SUB07-00082

Subdivision Name:	Ocotillo Estates Unit Five		
Type Request:	Major Preliminary		
Property Owner:	EP Park Hills II, LTD		
Developer:	EP Park Hills II, LTD		
Engineer:	Conde, Inc.		
Surveyor:	Conde, Inc.		
Location:	North of Ojo De Agua Drive and East of Via Descanso Drive		
Acres:	40.128	Representative District:	1
Planning Area:	Northwest	Present Zone:	PMD
Park Fees:	N/A	Park Zone:	NW-11

STAFF RECOMMENDATION:

Preliminary Plat

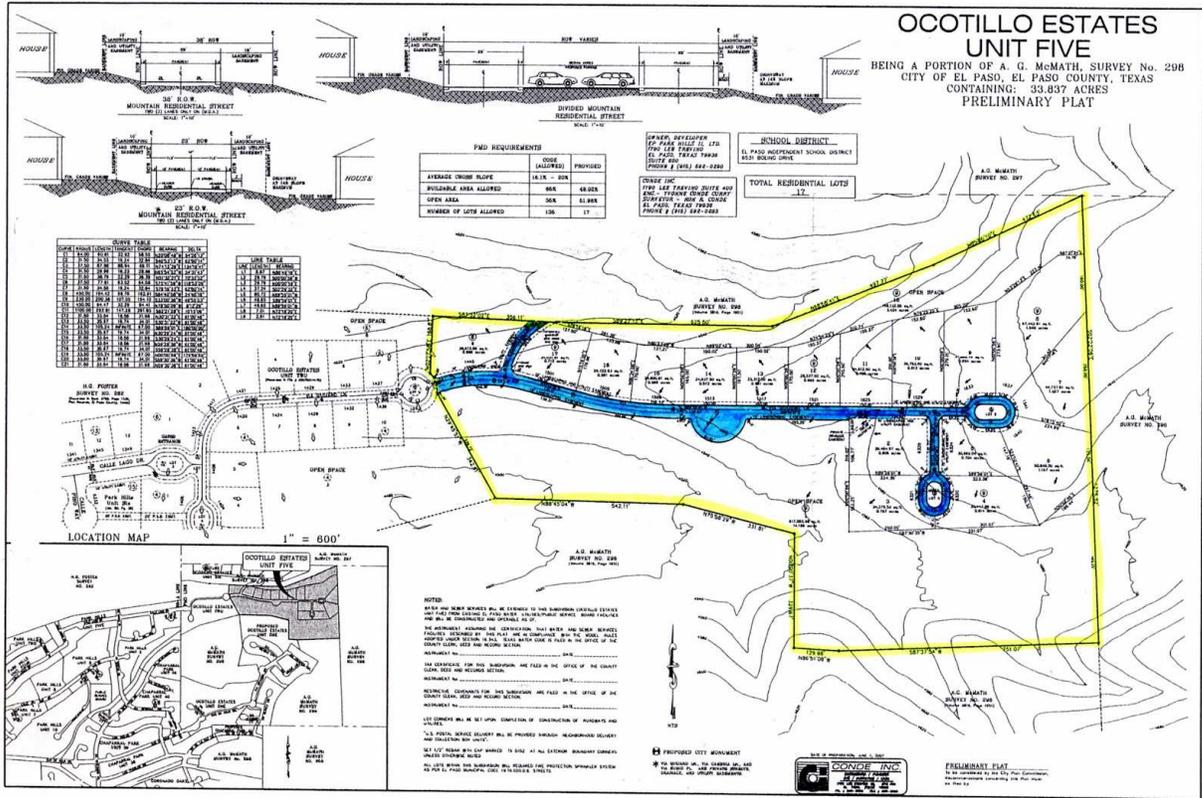
1. Provide maximum street grade.
2. Cul-de-sac does not comply with Subdivision Design Standards that require maximum length of 750ft. Length at Via Quijano Lane is 1,400ft.

2. There is an existing 8-inch diameter water main along Via Quijano Lane within Ocotillo Estates Unit Two. This water main can provide service up to the 4,560 foot contour. Water service for lots proposed above the 4,560 foot contour requires the construction of a new booster pump station.

4. An off-site water main extension is required from a future 8–inch diameter high pressure water main to be located within the proposed Ocotillo Estates Unit Three subdivision. Additional water main extensions are required along Via Quijano Lane, Via Cambria Lane, and Via Rubio Lane within Ocotillo Estates Unit Five. The Developer is responsible for all water main extension costs, as well as the acquisition of all required off-site easements.

7. There is an existing 8-inch diameter sanitary sewer main along Via Quijano Lane within Ocotillo Estates Unit Two. On-site extensions of this 8-inch main are required within Ocotillo Estates Unit Five. The proposed 8-inch gravity sewer main will be available for service to Lot 9, Block 6 and Lots 6-17, Block 9. The Developer is responsible for all sanitary sewer main extension costs.

8. Conventional gravity sanitary sewer service is not available for Lots 2-5, Block 9, Ocotillo Estates Unit Five. Service to these lots requires a low-pressure sanitary sewer system with privately owned grinder pumps at each lot.

For the oval shaped cul-de-sac turnarounds with landscaped islands, the minimum width of the roadway within the turnaround shall be twenty feet and on-street parking shall be prohibited within the turnaround per 19.16.020 (D.)(3); we request that parking signs be required to comply with the no parking requirement.

Attachment 3: Requested Modified Cross Section & Standard Cross Section

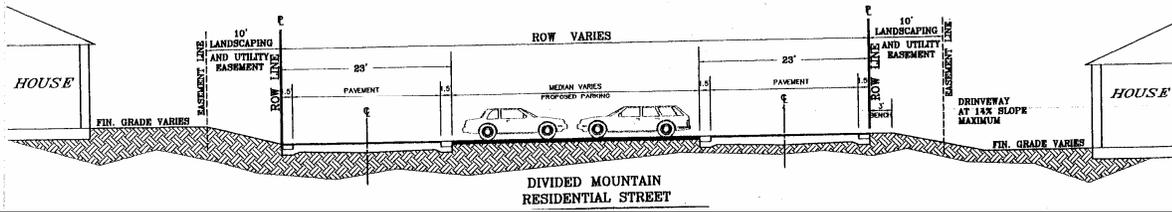
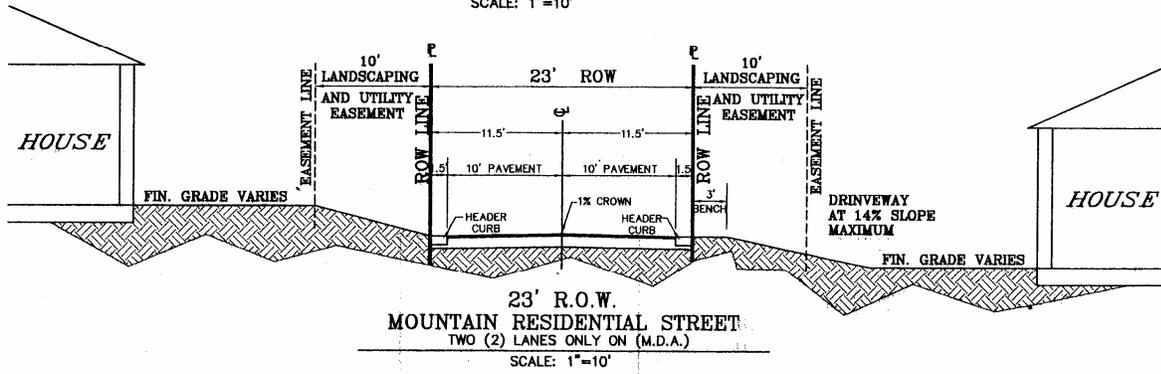
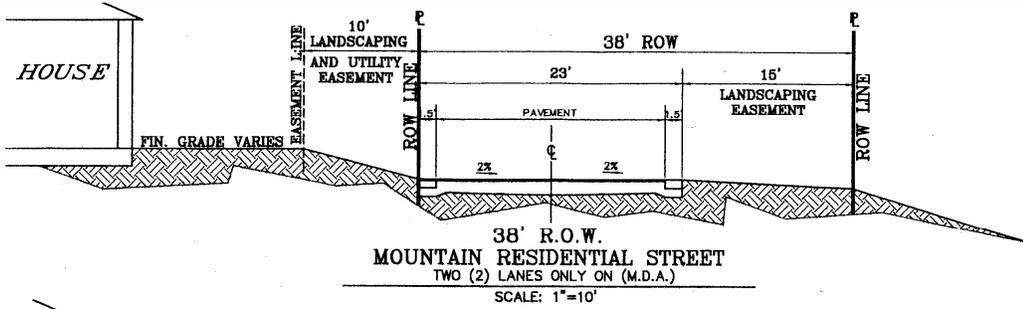
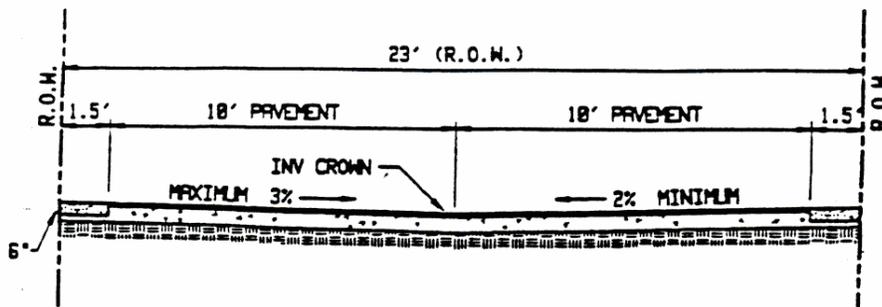
1. To allow clustered parking within the turnarounds (Via Rubio Place and Via Quijano Lane)
2. To allow for a 23' minimum width roadway in lieu of 20' roadway (at Via Cambria Lane, Via Rubio Place, and Via Quijano Lane)
3. To allow for a 38' minimum width roadway in lieu of the 20' foot roadway (at Via Quijano Lane)
4. To allow for a cul-de-sac length exceeding 750 feet (Via Quijano Lane is 1400 ft)

The Development Coordinating Committee recommends **approval** of the requested modifications under modification condition #3. The DCC recommended **approval** of the Ocotillo Estates Unit Five subdivision on a **Major Preliminary** basis subject to the following conditions and requirements:
